WILLIAMSON COUNTY, TEXAS

CHANGE ORDER NUMBER: 2

Project: 14IFB00219
Roadway: Lakeline Blvd Phase 2
CSJ Number: _____

Change Order No. 2

FLEXIBLE DELINEATOR POSTS EMBEDDED & S

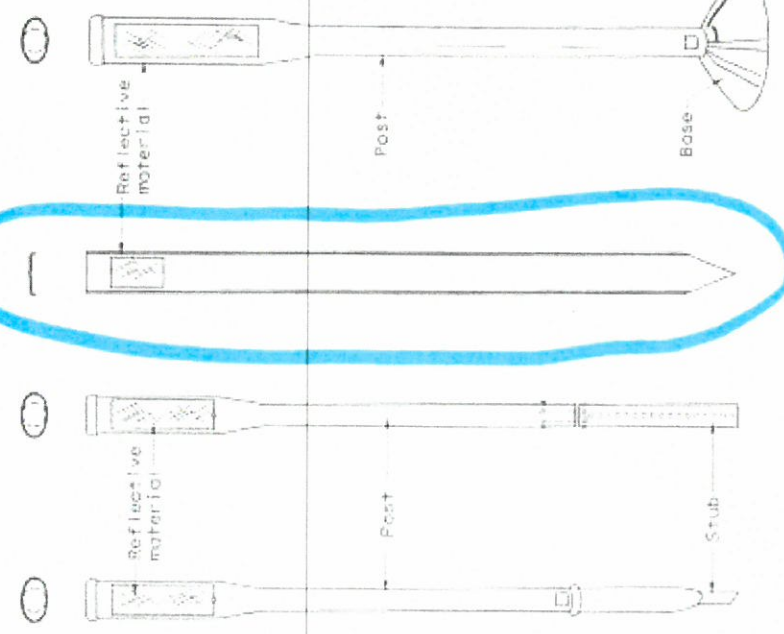
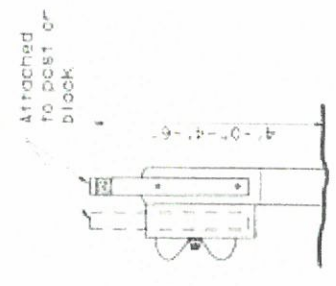
ITEM	DESCRIPTION	QTY	UNIT
658-2329	INSTL DEL ASSM (D-SW) SZ 1 (FLX) GND	74	EA
3268-WC01	D-GR HMA (QC/QA) TY-B PG64-22 BONUS/PENALTY	1	LS
3268-WC02	D-GR HMA (QC/QA) TY-C SAC B PG70-22 BONUS/PENALTY	1	LS
9999-010	ADDITIONAL PROJECT SIGNS	1	LS

SIGNING AND
PAVEMENT MARKING PLAN
STA. 1+00 - STA. 10+00

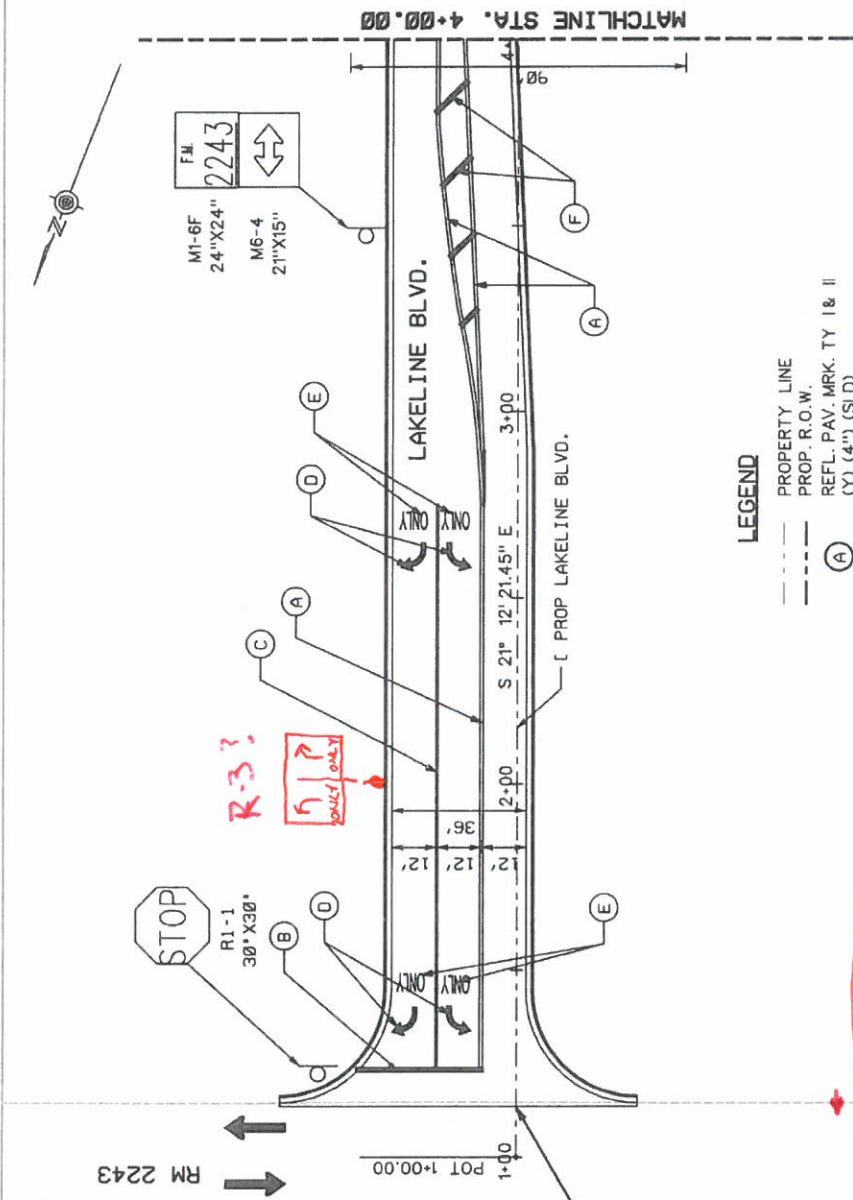
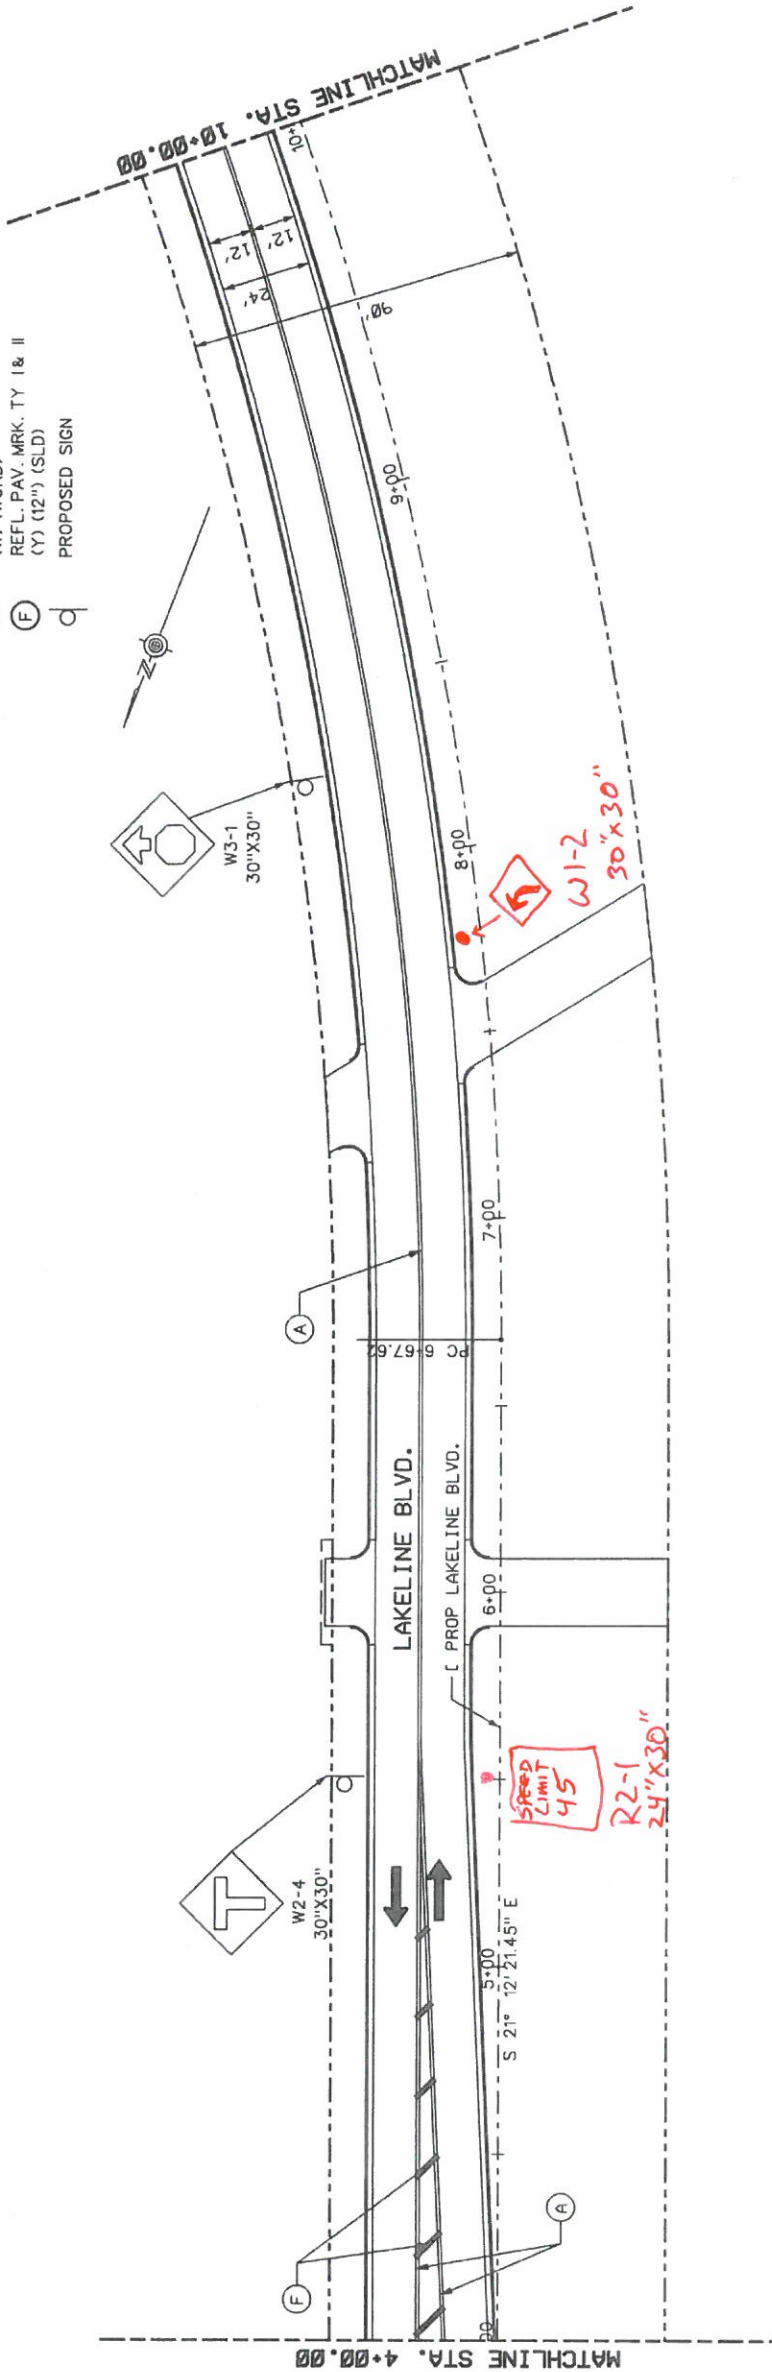
96" x 36" W1-7 T

★ OBJECT MARKERS & CURB CUTS
